# GRADING AND EROSION CONTROL PLAN

## JUDGE ORR ROAD RV PARK AND STORAGE

### EL PASO COUNTY, COLORADO

**JUDGE ORR ROAD RV PARK & STORAGE**  
**COLORADO SPRINGS, COLORADO**  
**STORM SEWER PROFILES**

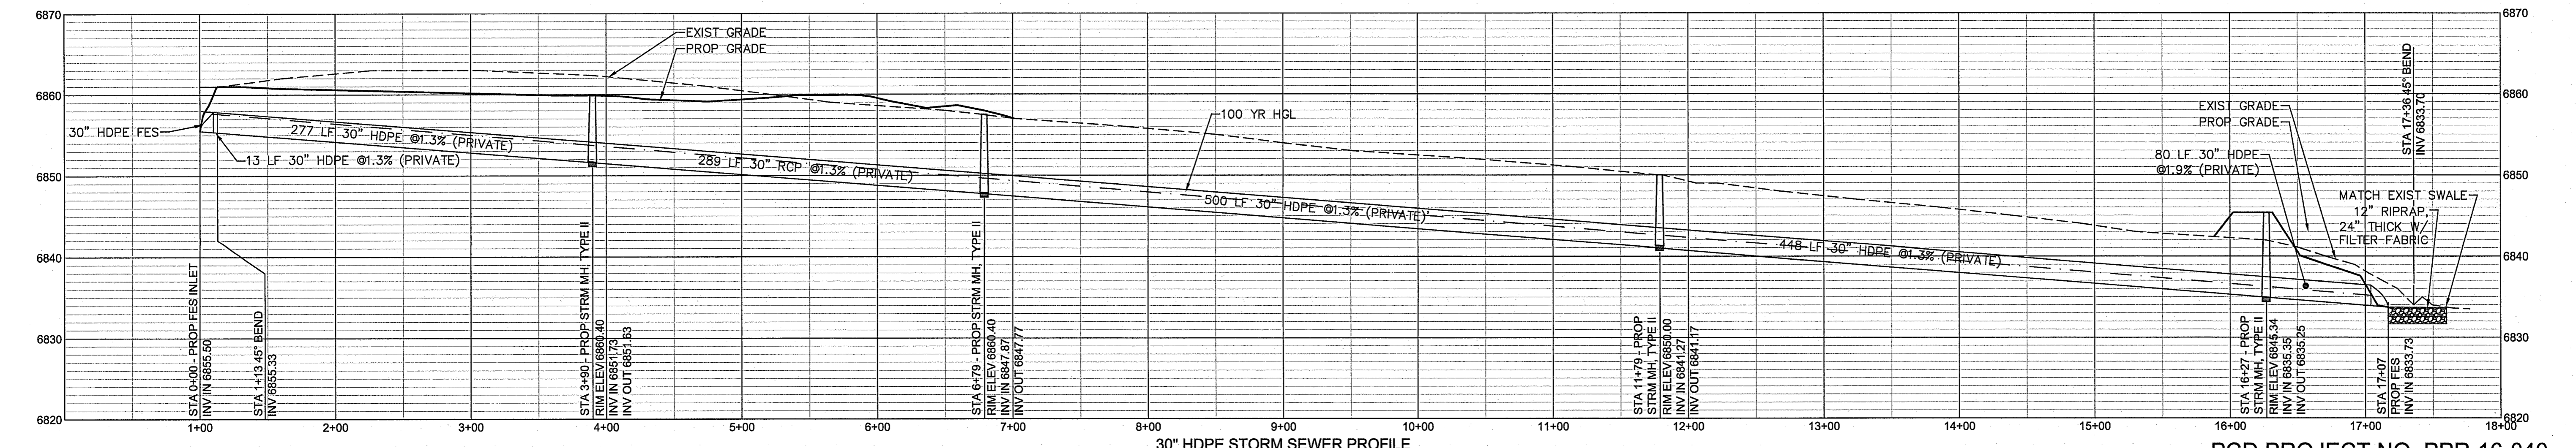
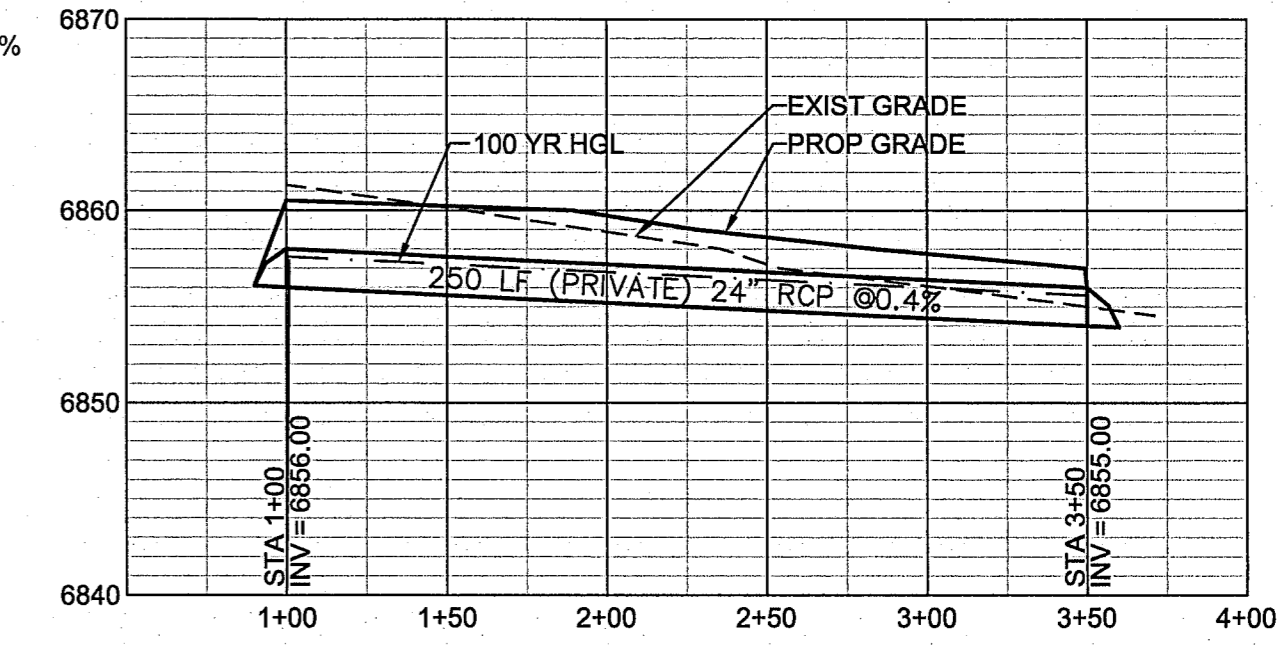
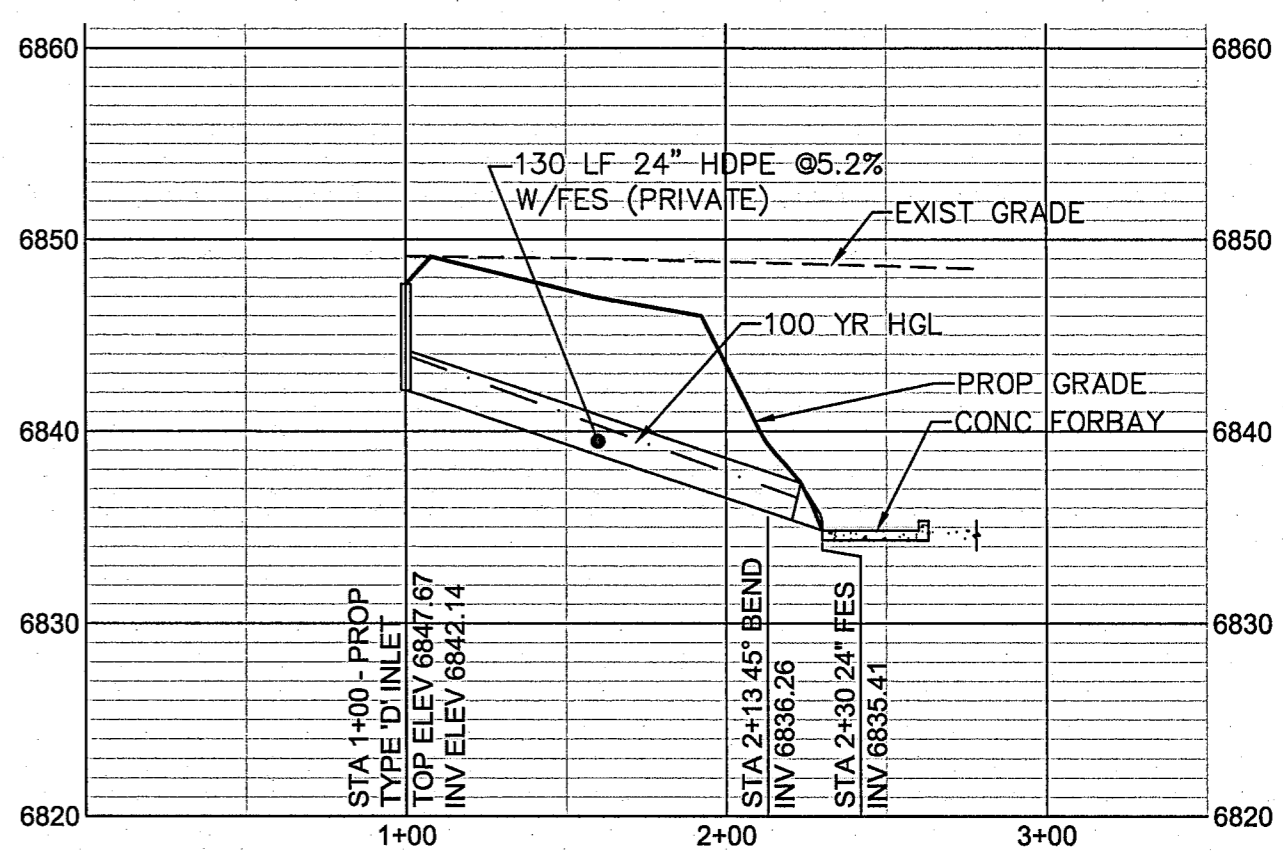
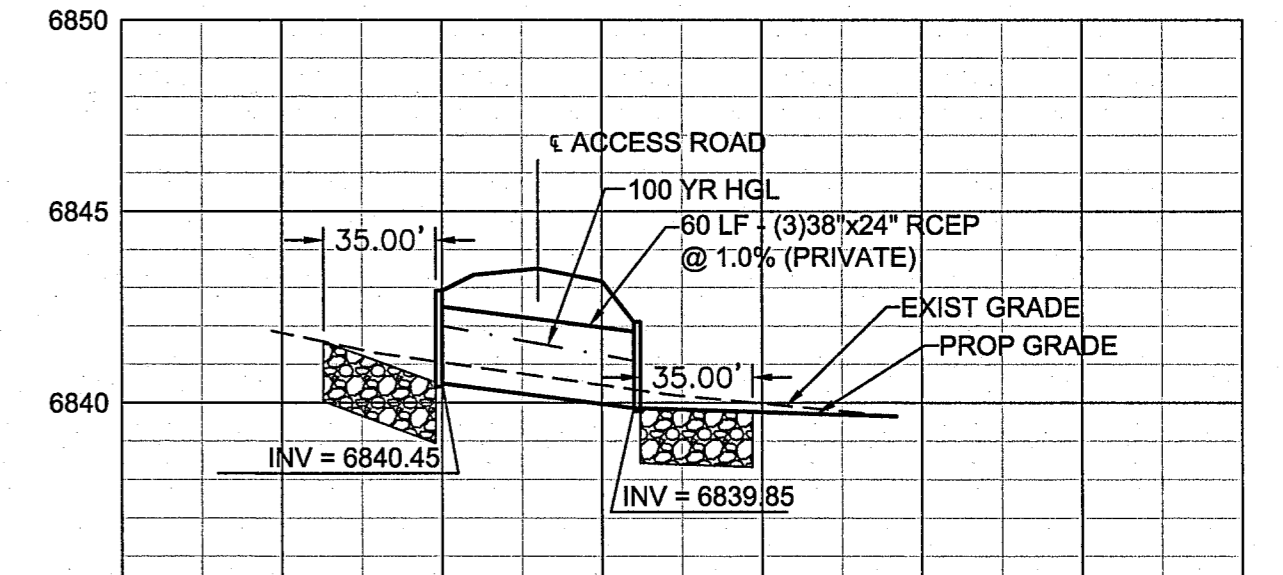
provide construction details for wingwalls.  
Unresolved. We will accept CDOT M&S details.

provide construction details for wingwalls.

Unresolved. We will accept CDOT M&S details.
